THM 4T65-E UPDATE HANDBOOK

INTRODUCTION THM 4T65-E UPDATE HANDBOOK

Technical Service Information

Figure 51

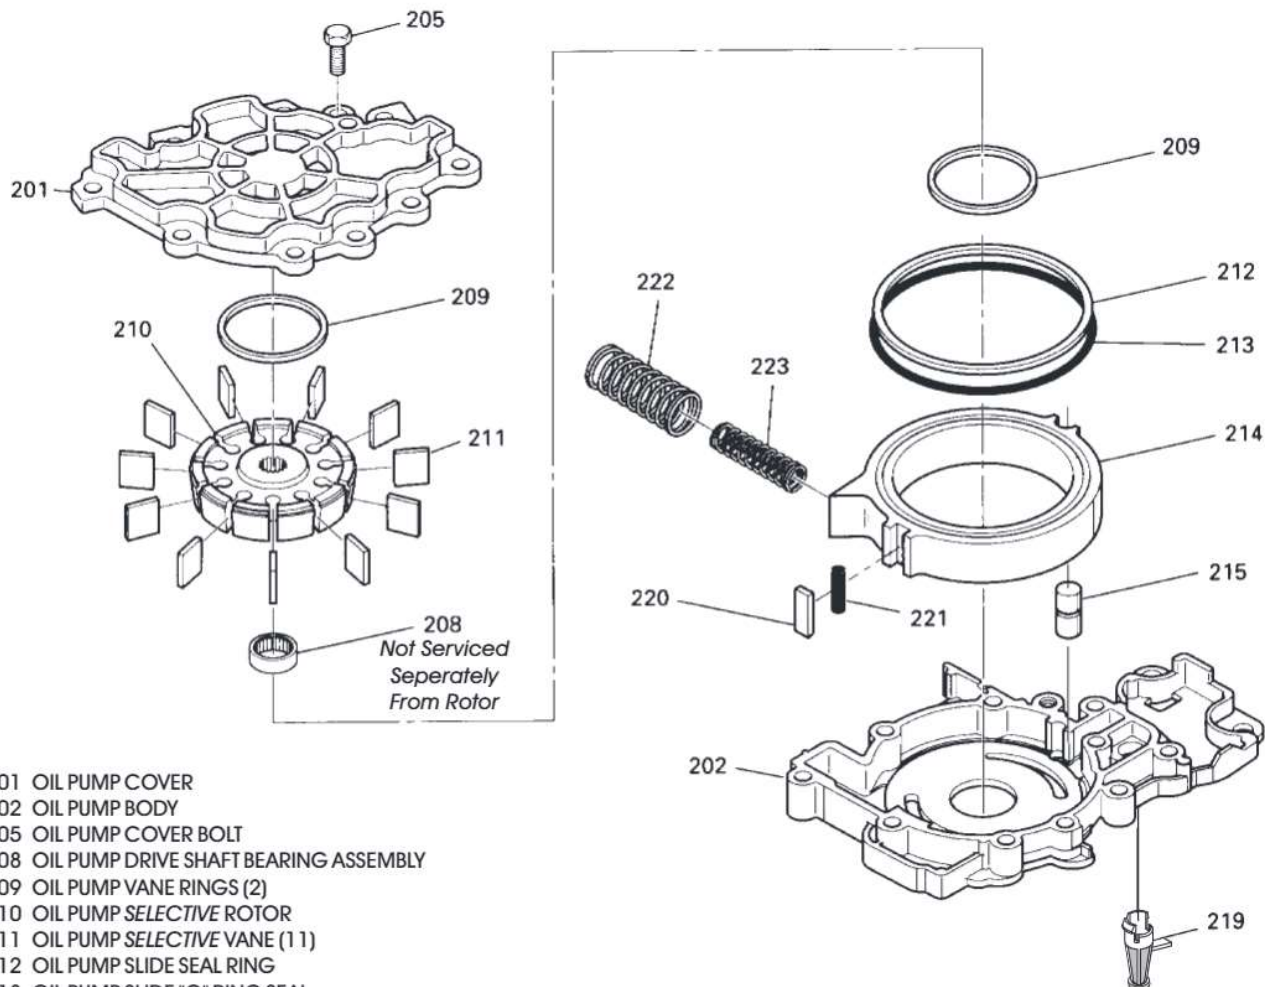
- (1) OIL PUMP ASSEMBLY - Changed to a “3 Piece” design, as shown in Figure 52. The “3 Piece” design now incorporates the rotor support sleeve in the pump instead of the valve body. The previous design “2 Piece design level pump is illustrated in Figure 51.

Figure 52

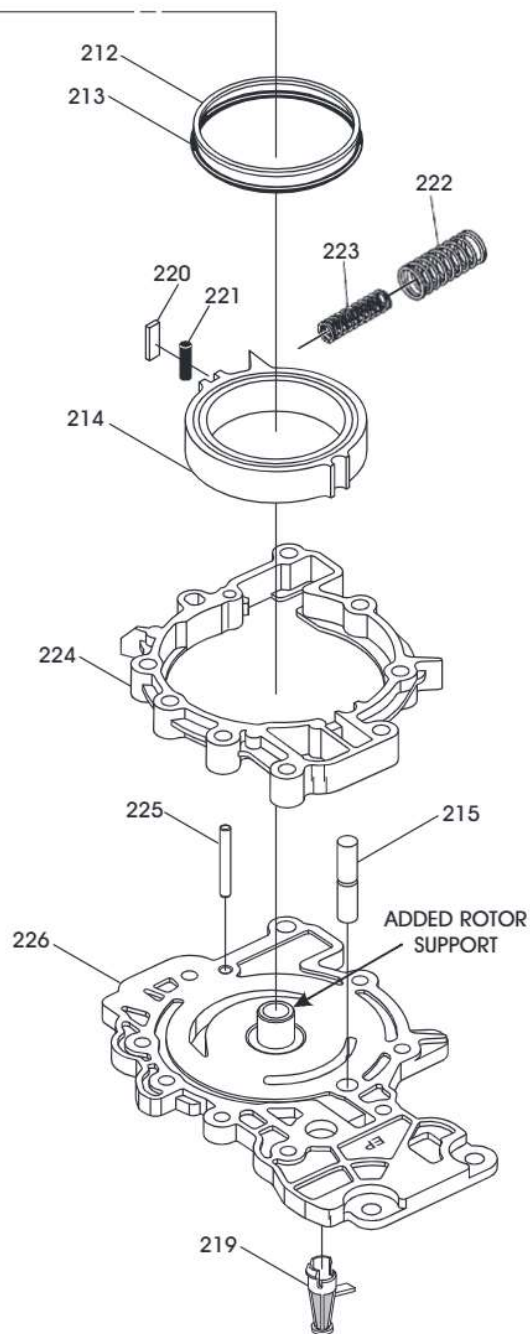
- (2) OIL PUMP ASSEMBLY RETAINING BOLTS - Are a different length than the previous design level oil pump bolts.
- (3) VALVE BODY ASSEMBLY - The pump rotor support sleeve has been removed from the valve body to accommodate the “3 Piece” design level pump assembly, as shown in Figure 50.

Figure 56

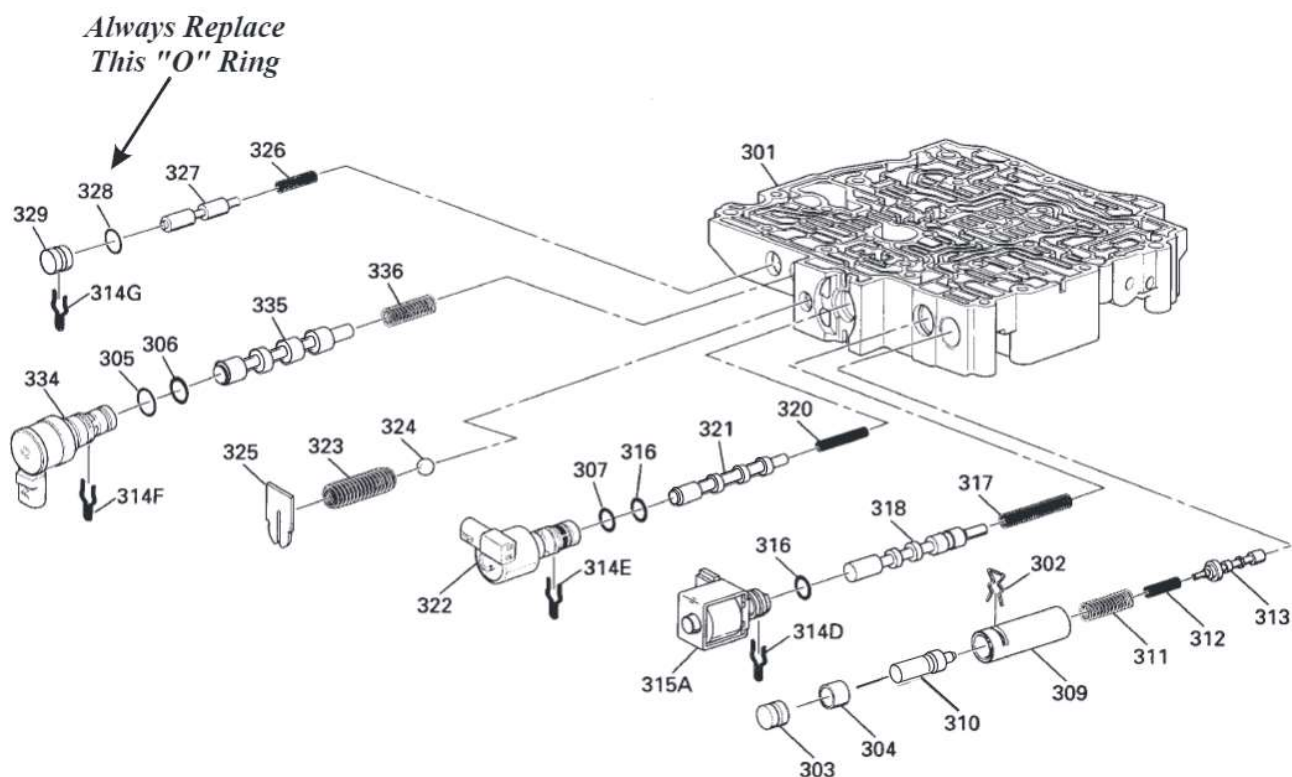
CAUSE: The cause may be, a leaking bore plug “O” ring on the Torque Converter Regulator Valve train. Refer to Figure 54 to see a partial hydraulic circuit of the Torque Converter Regulator valve when the TCC is released. Refer to Figure 55 to see a partial hydraulic circuit of the Torque Converter Regulator valve when the TCC is applied. Notice, when there is a leak in the TCC Signal Circuit, the torque converter regulator valve may move to the left causing insufficient converter apply pressure, allowing the Torque Converter Clutch to slip, causing a surging sensation or the P0741 code.

CORRECTION: Refer to Figure 56 and 57 for the valve locations in the valve body and replace the “O”ring on the Torque Converter Regulator Valve bore plug, item number 328, as shown in Figure 56.

Figure 67

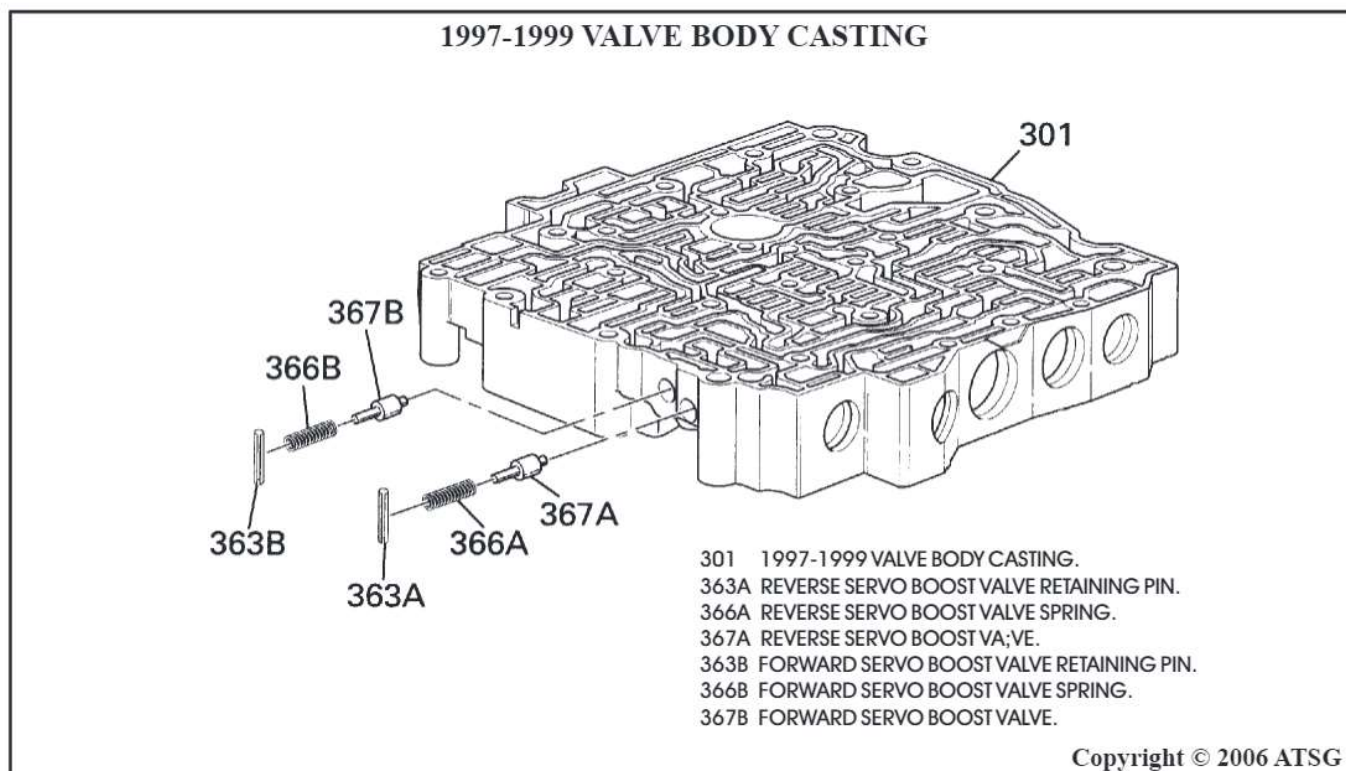
- (1) SERVO BOOST VALVES - Complete valve trains eliminated, as shown in Figure 68.
- (2) VALVE BODY CASTING - Servo boost valve bores are now cast shut, as shown in Figure 68.

Figure 69

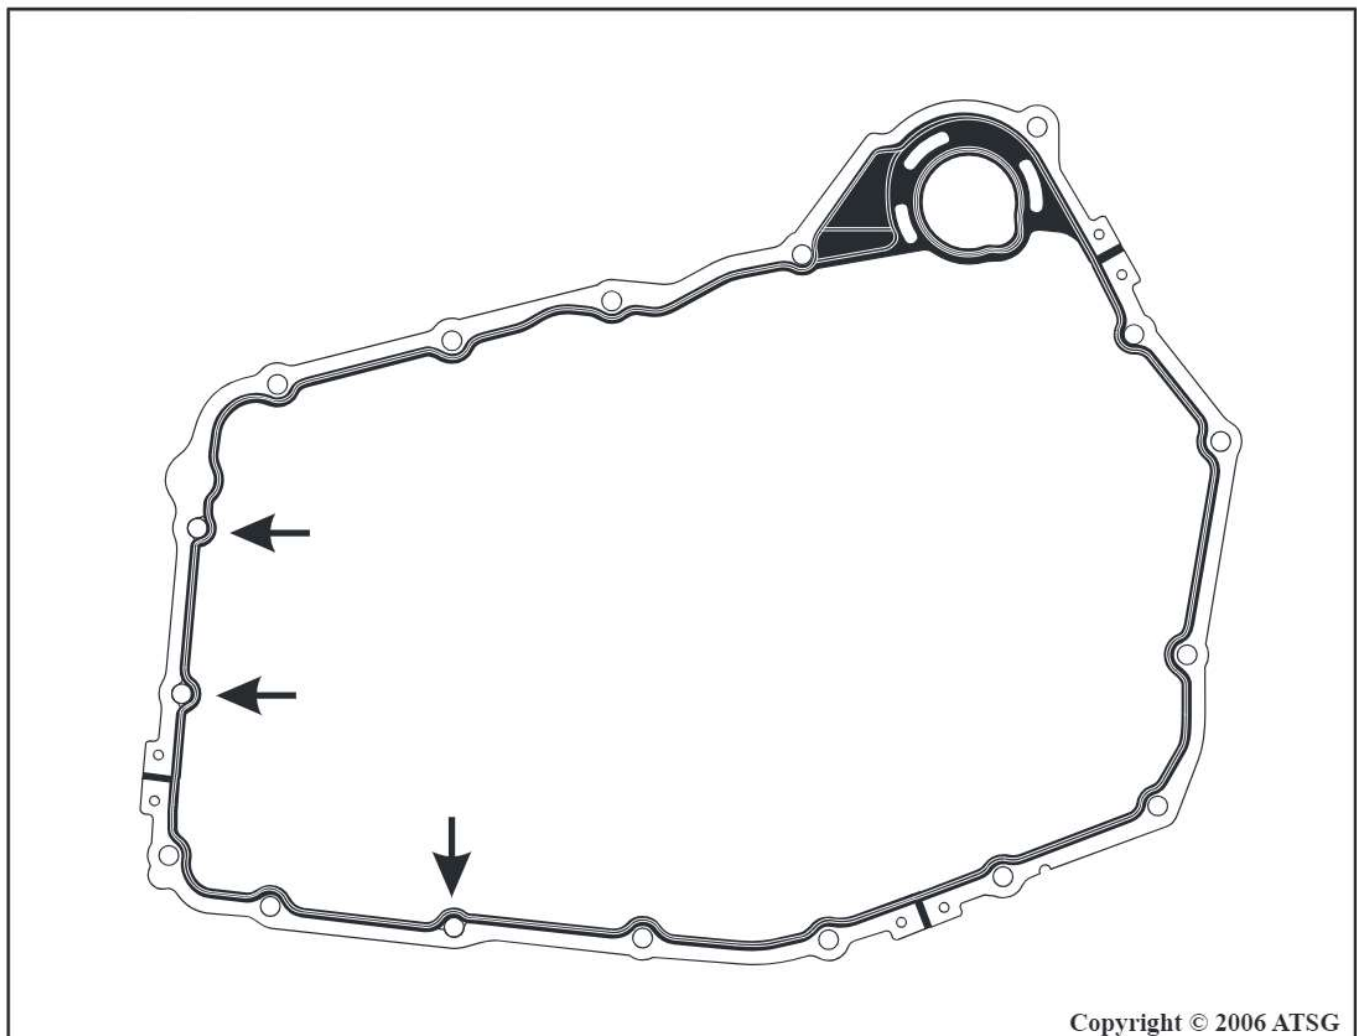
COMPLAINT: Vehicle returns after rebuild with a fluid leak. After investigation, you discover that the structural side cover is cracked around one of the three retaining bolt locations, shown on the gasket, in Figure 69.

Explanation: The three gasket bolt hole locations, shown in Figure 69, do not have any metal support around the inside perimeter of the gasket, on the side the arrows are on. This allows zero support on the inside perimeter, and if overtorqued, will crack the structural side cover,

Figure 70

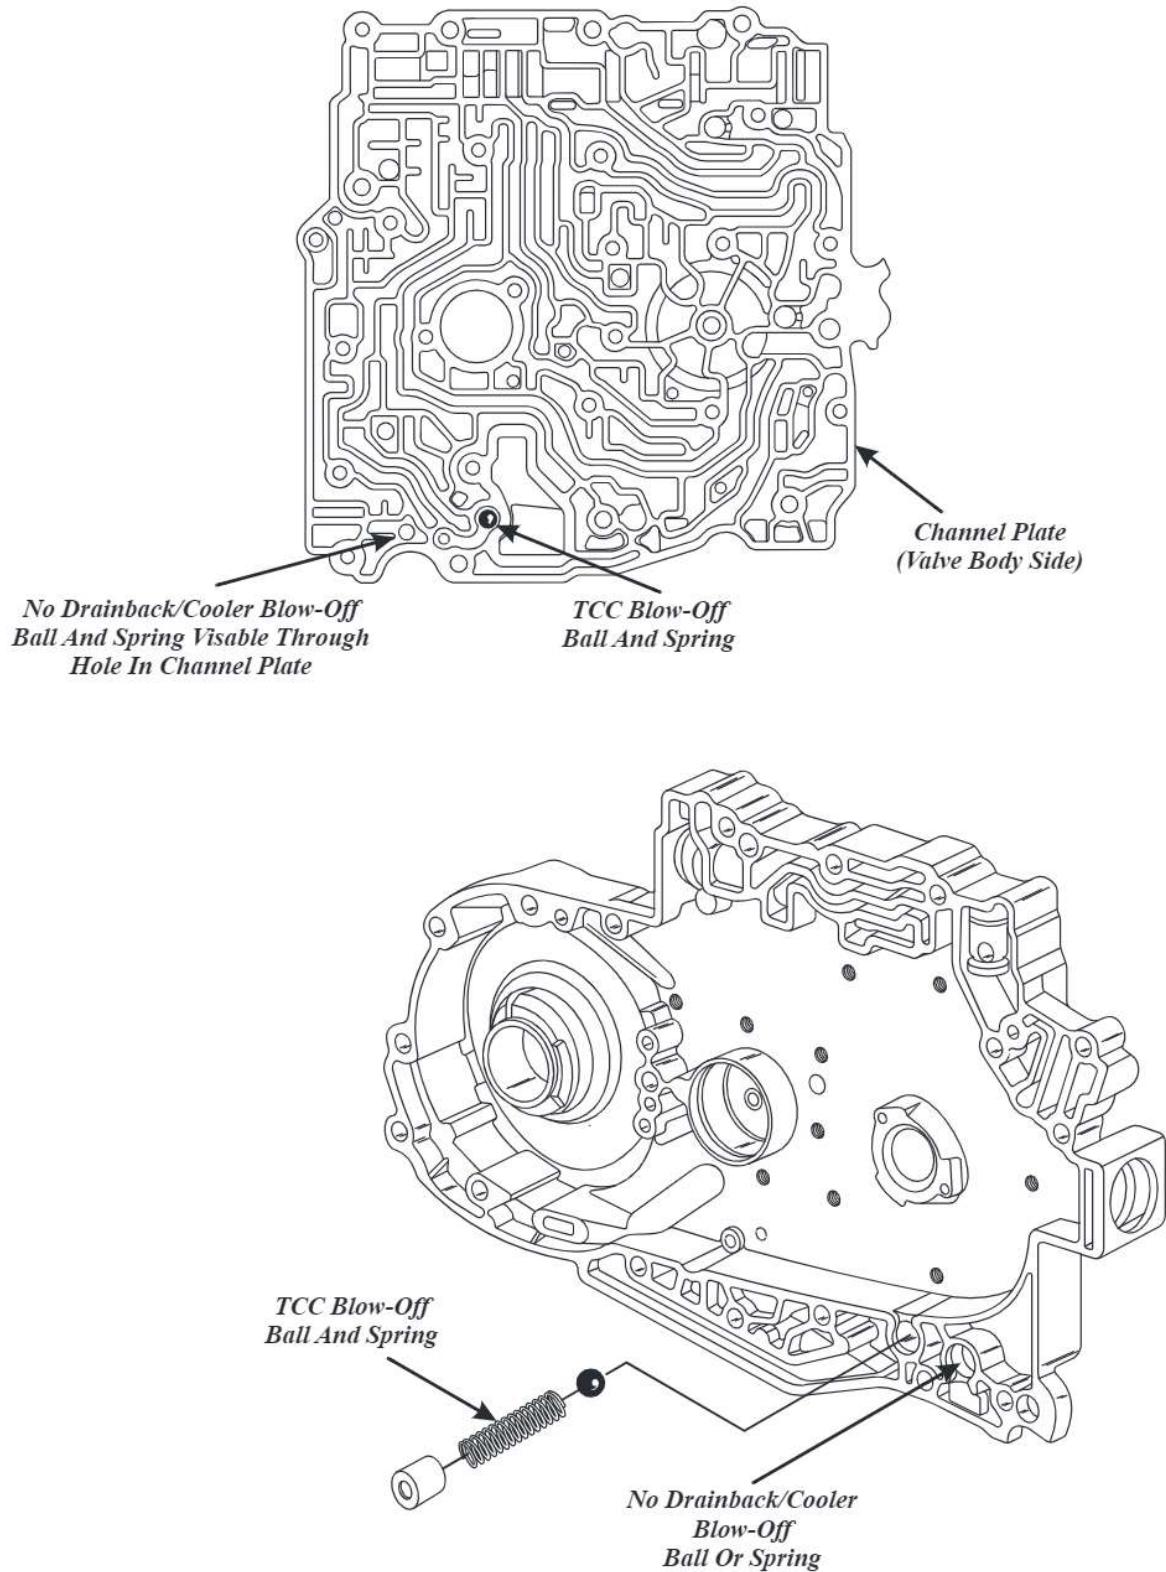
- (1) CHANNEL PLATE - Drainback ball, spring, and retainer added to the channel plate next to the torque converter blow-off ball and spring. Channel Plates built "Before" January 19, 2004 are shown in Figure 70, and the Channel Plates built "After" January 19, 2004 are shown in Figure 71.
- (2) RETURN COOLER FITTING - The January 19, 2004 and later cooler line case fittings both have the same threads, which is 9/16-18 UNF, and the return line cooler case fitting does not contain a ball and spring. Refer to Figure 72.
The prior to January 19, 2004 cooler line case fittings have different threads. The supply cooler line case fitting has a 1/4-18 NPSF thread. The return line cooler case fitting has a 3/8-18 NPSF thread, and contains the drainback ball and spring. Refer to Figure 72.

- (1) If a prior to January 19, 2004 Channel Plate, without the drainback ball and spring, is installed on a transaxle built after January 19, 2004, the result will be severe converter drainback.
- (2) If a January 19, 2004 and later Channel Plate is installed on a transaxle built before January 19, 2004, the result will be 2 drainback balls in the circuit, and severe restriction of lube oil.
- (3) If a prior to January 19, 2004 Channel Plate, without the drainback ball and spring, is installed on a transaxle built after January 19, 2004, with the intention of installing the return line cooler case fitting with the drainback ball, this can not be accomplished as the thread sizes are different between case and fitting. Refer to Figure 72.

Figure 71

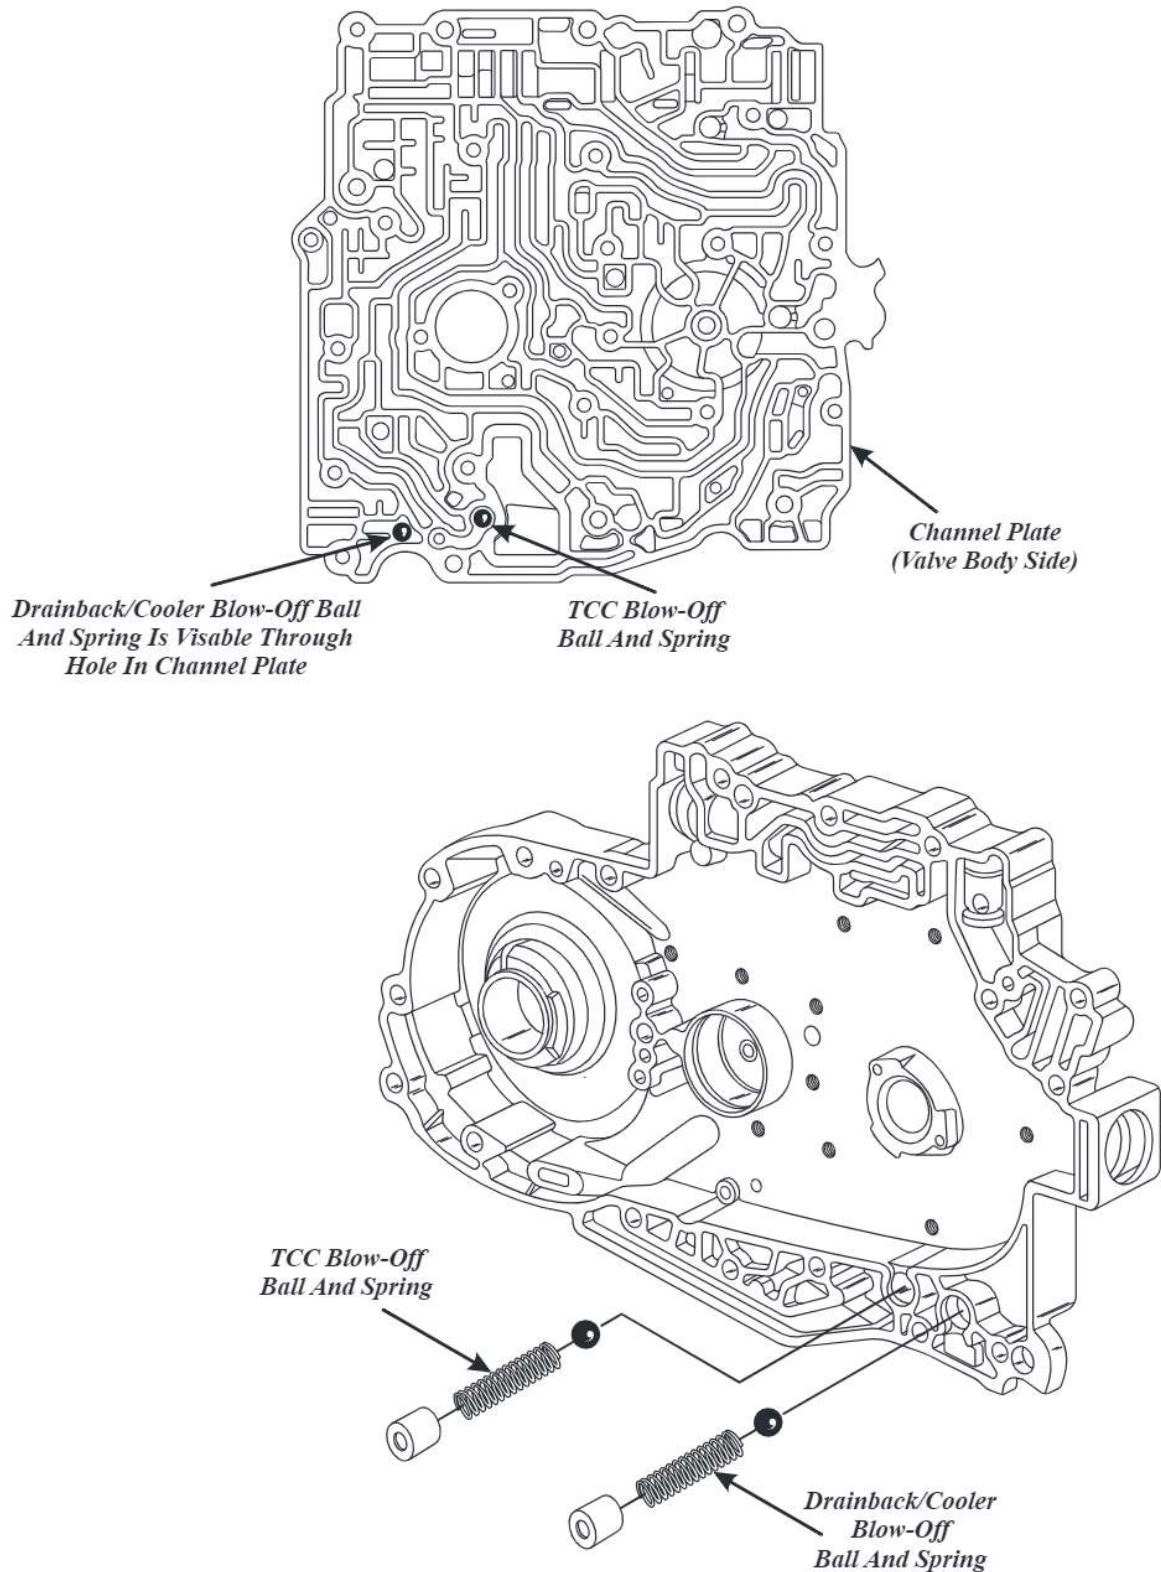
CHANGE: Beginning on January 19, 2004, all 4T65-E transaxles were built with the drainback ball removed from the return cooler line fitting, and relocated in the channel plate next to the torque converter blow-off ball and spring. Refer to Figure 71.
